ADMINISTRATIVE HEARING OFFICER

STAFF REPORT

PROJECT: 626 S. Whitcomb Four Plex, FDP140023

This is a request for a consolidated Project Development Plan/Final Plan to construct two additional dwelling units to the rear of an existing two-unit building ('duplex'), creating a 4-unit, multifamily building ('four plex'). Each unit features two bedrooms for a project total of 8 bedrooms, and a total floor area of 4,295 square feet. Site upgrades to support the multifamily building include five new parking spaces, bicycle parking, a trash enclosure, and new site landscaping. The project proposal is located at 626 South Whitcomb Street, a 9,500 square foot (.22 acre) lot in the Neighborhood Conservation, Buffer (N-C-B) Zone District. Two Modification of Standard requests accompany the proposal:

SITE PLAN

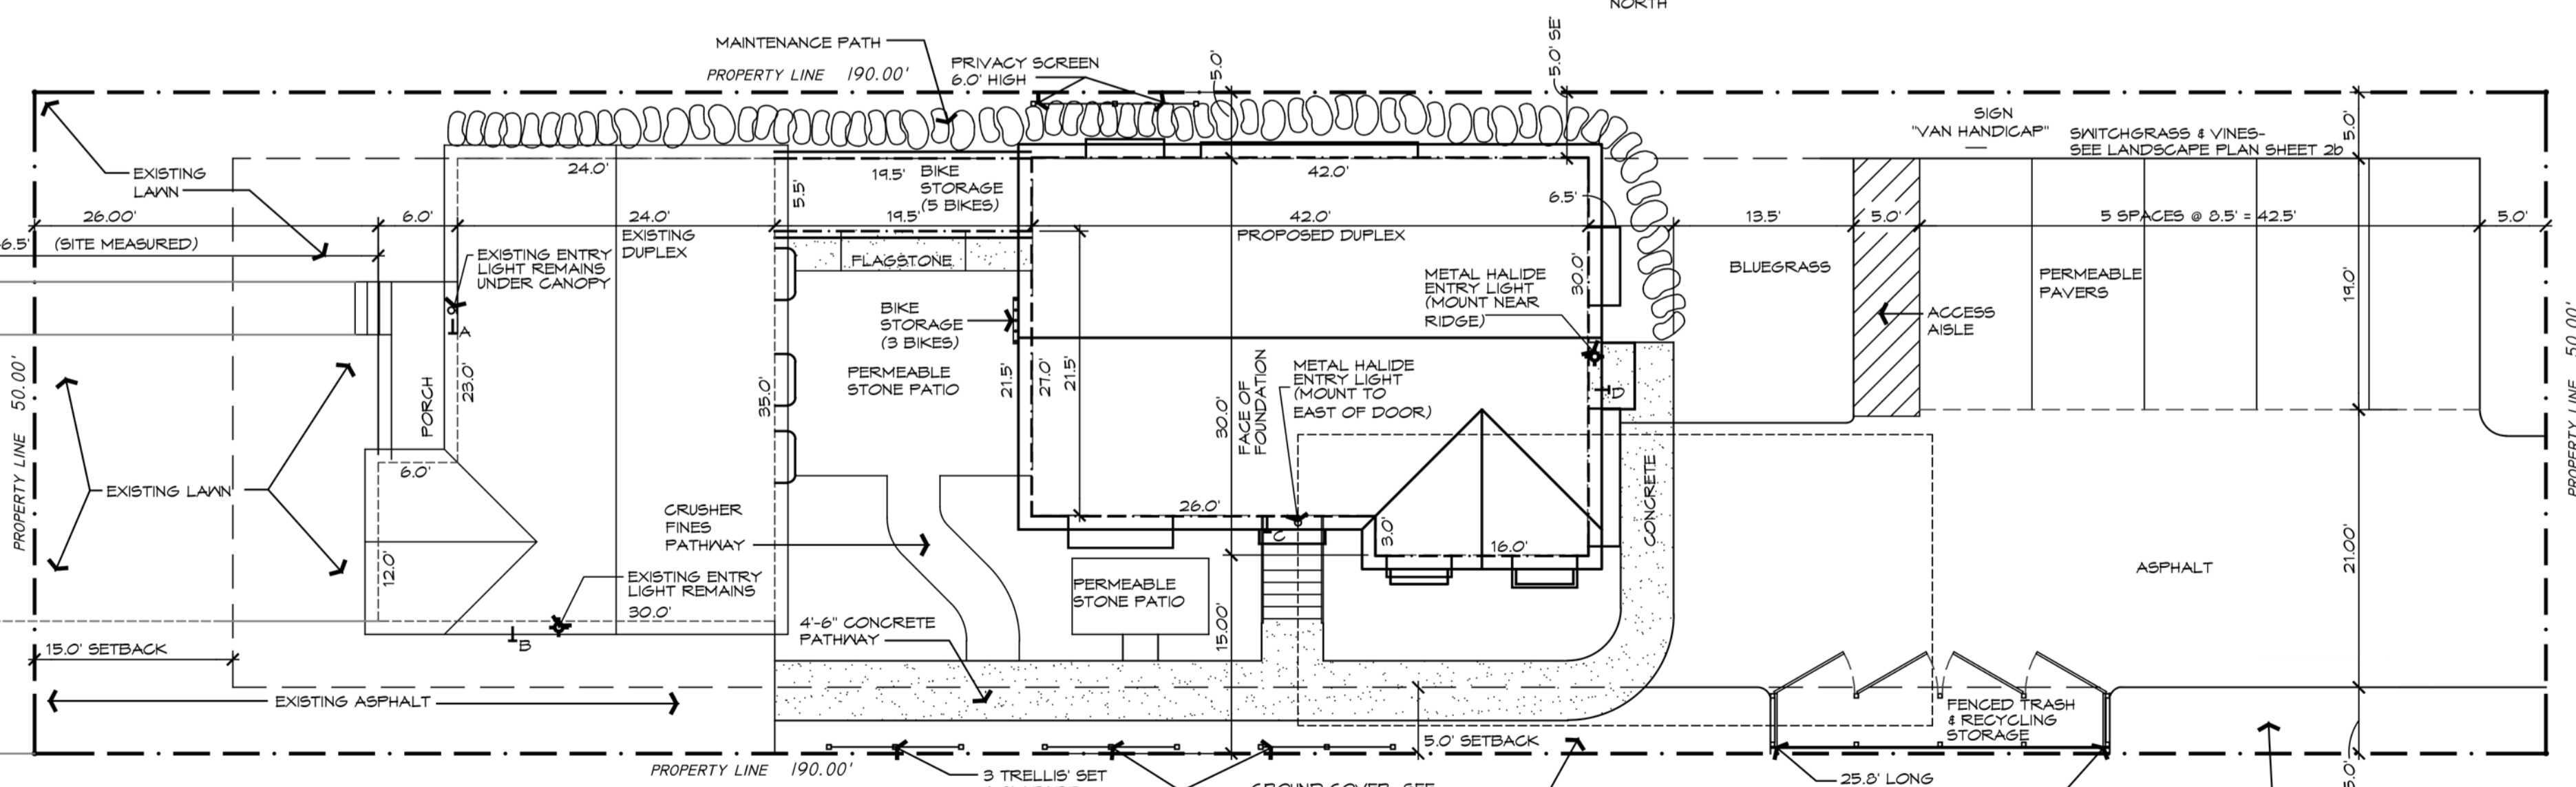
The applicant requests a modification to reduce the two-way drive aisle width for the parking area from 24-feet to 21-feet, as there is limited lot width to accommodate the requirements for parking lot setbacks, drive aisle width, and parking stall length on a 50-foot wide lot that is common to this area of the City and this zoning district.

The reduction in drive-aisle width by 3-feet is nominal when considering the expected movements and level of vehicle traffic that will utilize the small 5-space parking lot. There will only infrequently be overlap where vehicles will be entering and existing the parking lot given the low number of spaces and the relatively infrequent trips generated by the dwelling units, as compared to a commercial or retail operation with high turnover and a larger parking area. When simultaneous vehicle use of the parking area does occur, it is aided by a large turn-around for vehicles to utilize as they back out of their spaces. Further, although reduced in width, 21-feet remains adequate for two vehicles to safely pass one-another in the drive-aisle.

- A. Staff finds the request for the Modification of Standard to Section 3.2.2(L) to decrease the two-way drive aisle width in the parking lot to 21-feet is justified by the applicable standards of 2.8.2(H), and that the granting of the modification would not be detrimental to the public good.

The request satisfies Section 2.8.2(H)(4) as the plan as submitted will only diverge from the standard in a nominal and inconsequential way when considering the entire development plan. Two vehicles may still safely pass one another in the drive-aisle even with the reduced width, and the limited amount of movement in the relatively small parking lot means vehicles leaving and entering at the same time will be an uncommon event.
